## NSLPP MEETING HELD ON 01/11/2023

**ADDRESS/WARD:** 3 Commodore Crescent, McMahons Point 2060 (E/W)

**APPLICATION No:** DA178/23

**PROPOSAL:** Alterations and additions to a heritage listed dwelling including partial demolition, addition of garden pavilion and reconstruction of double height southern verandah.

Figure 1: Proposed Ground Floor Plan

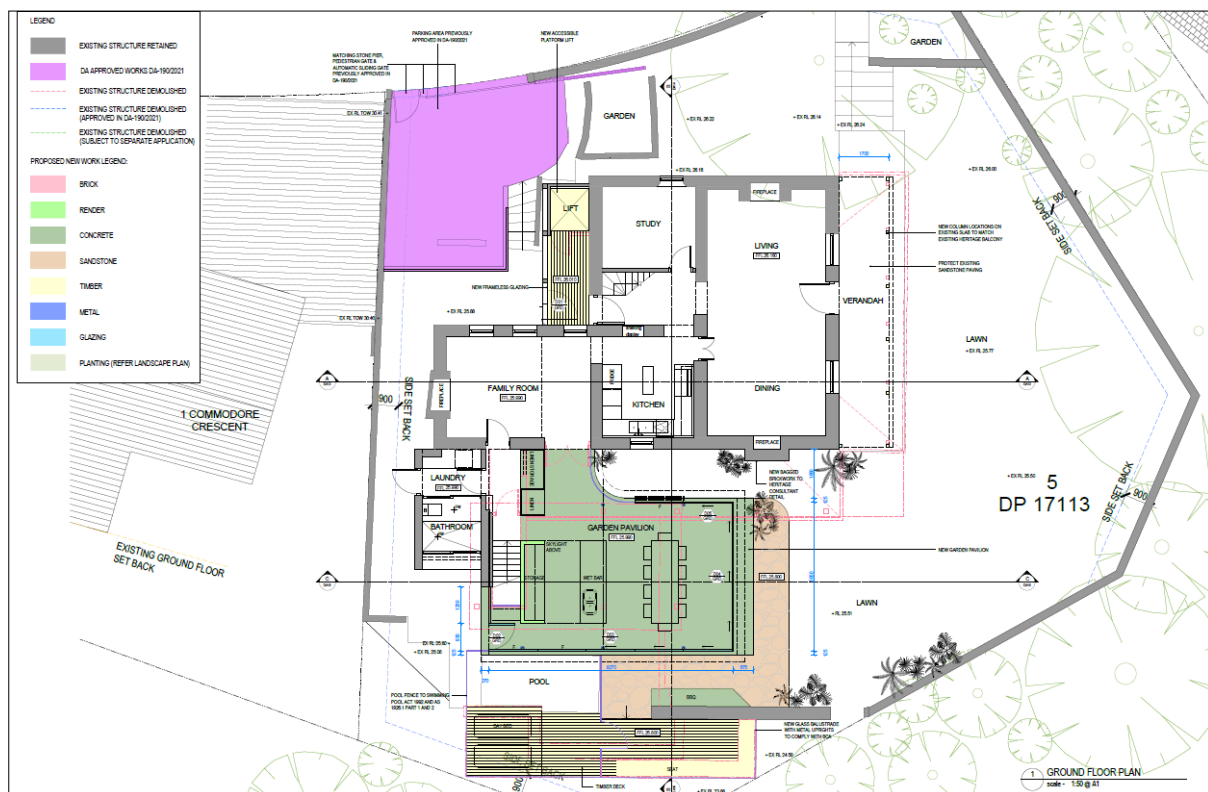
*With reference to the historical evidence, the western verandah was not part of the original dwelling and was a later add, that appeared following the 1968 application for alterations and additions by Ian MacKay Cox. The western verandah was reinterpreted by the Clive Lucas Stapleton as part of their restoration works and redesigned to complement the restored southern verandah with an overall height that was comparably lower than the restored primary southern verandah facing the water.*

*A portion of the ground floor of the northern verandah is used as a storage room and therefore partially encloses the verandah. The installation of a lift in this portion of the verandah will have an acceptable level of impact subject to the verandah remaining legible continues to express its lightweight and open form. As such, whilst the installation of a new lift is supported in the north-eastern end of the verandah, the proposed glazing to enclose the rest of the verandah is not supported.*

- c) The installation of the lift within the north-eastern end of the northern verandah is supported in principal, however, the detailing of the lift enclosure, elevations and balustrade require more sensitive detailing to match existing and to avoid a solid timber wall being created. The enclosure of the remaining verandah with glazing is not supported as it will adversely impact on the perceived bulk and scale of the verandah element. A condition is recommended to address this.*

A7 The proposed lift is to be housed as an independent element:

- within the dimensions and form of the existing verandah so that its overall appearance and expression as a lightweight and open form is retained,
- The north-eastern elevation to the lift is to retain the vertical timber cladding detailing together with a visual break between the upper verandah level to retain a visual gap which reflects first floor level - solid timber wall on the NE side of the verandah is to be avoided,
- retain the multi-paned windows in situ noting this element will function as a blind window - the central verandah bay is to be retained as open without a window above the balustrade level.
- Maintain a 50mm clearance on all sides of the lift structure.

Figure 3: Proposed Southern Elevation

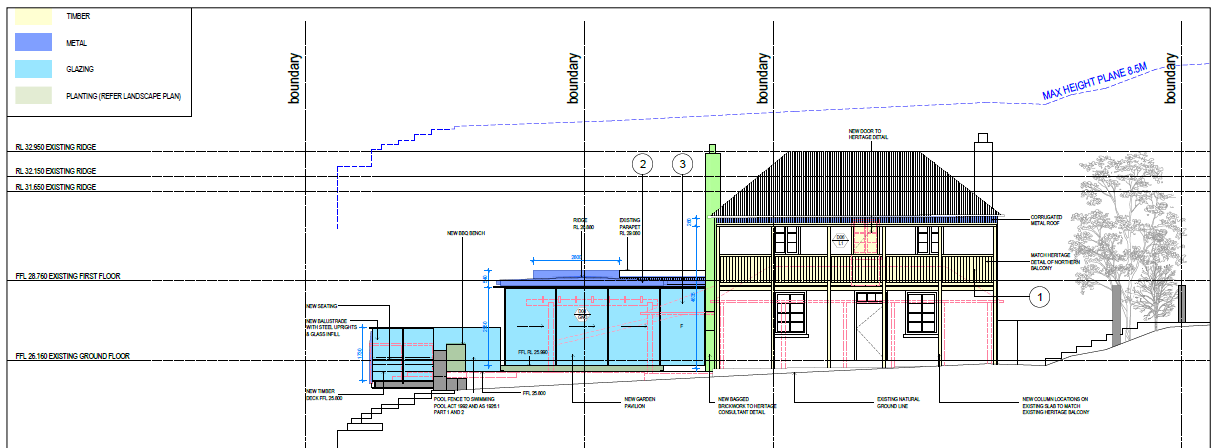
*The southern, water facing elevation of the existing cottage has a high degree of heritage significance because it represents the original early form of the cottage, noting that the cottage has continued to evolve predominantly to the rear (northward), to accommodate ongoing needs to meet contemporary living standards.*

*The southern verandah and Georgian windows were restored by Clive Lucas Stapleton Architects, and as supported by their Summary of Research notes, to their earliest known state. This work makes an important contribution to the overall understanding of the heritage item, its significance, interpretive qualities and its evolving form as one of the oldest houses in North Sydney. This understanding is especially relevant in light of the loss of undocumented fabric condition elsewhere on the site and as required under Article 31 – Documenting evidence and decision; Article 32 – Records and Article 33 – Removed fabric, of the Burra Charter undermining the ongoing understanding of the evolving history of the cottage and site generally.*

*With reference to the above, the proposed new double height verandah is not supported in this important historical elevation. However, as discussed below, the changes to the heritage item to meet amenity and contemporary living standards on lesser significant elevations is supported, such as along the western and northern elevations.*

- d) That the proposed double storey verandah and work to the southern elevation be excluded in favour to retention of the existing remain single storey verandah. This is in support of the documentary evidence presented in the summary of research undertaken by Clive Lucas Stapleton.*

A6. The proposed double storey verandah and works to the southern elevation are to be deleted from the plans and the existing ground floor verandah retained as a single storey element.
